SUNDRY NOTICES AND REPORTS ON WELLS

Cedar Canyon 22 #1H

OXY USA Inc. respectfully requests to amend the APD for the Cedar Canyon 22 #1H, API No. 30-015-40668 with the following changes.

AMENDED APD:

Cedar Canyon 22 #1H
Eddy Co, New Mexico

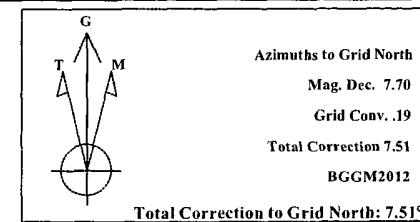
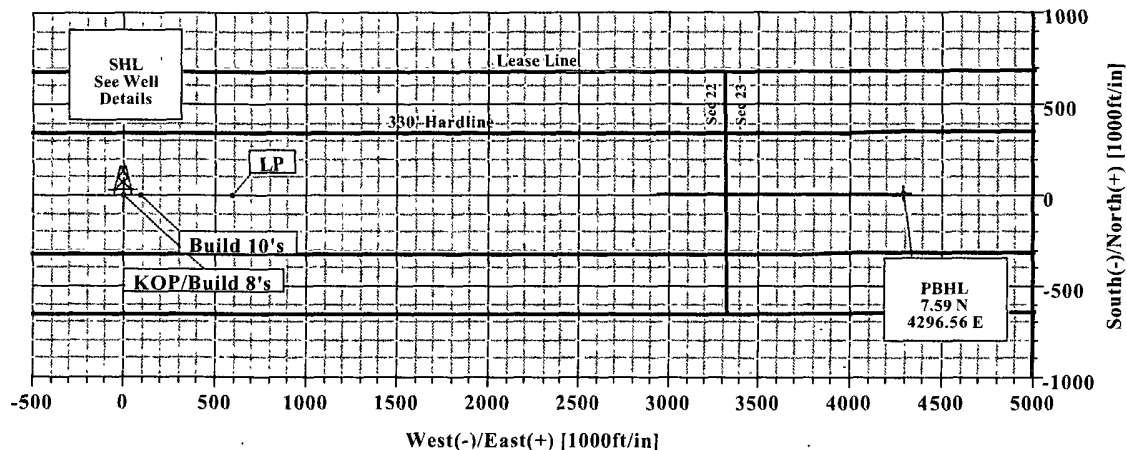
1. Amend the proposed TD's. 7926'-TVD 11941'-TMD
2. Amend proposed directional drilling plan, see attached.
3. Amend surface casing and cementing program, per BLM recommended setting depth, see attached.
4. Amend intermediate casing program, see attached.
5. Amend production casing and cementing program, move DVT, see attached.

SECTION DETAILS										
Sec	MD	Inc	Azi	TVD	+N/-S	+E/-W	DLeg	TFace	VSec	Target
1	0.00	0.00	89.90	0.00	0.00	0.00	0.00	0.00	0.00	
2	7261.43	0.00	89.90	7261.43	0.00	0.00	0.00	89.90	0.00	
3	7636.43	30.00	89.90	7619.53	0.17	95.95	8.00	89.90	95.95	
4	8233.34	89.69	89.90	7906.00	1.04	589.06	10.00	0.00	589.06	
5	11940.90	89.69	89.90	7926.00	7.59	4296.56	0.00	0.00	4296.57	PBHL
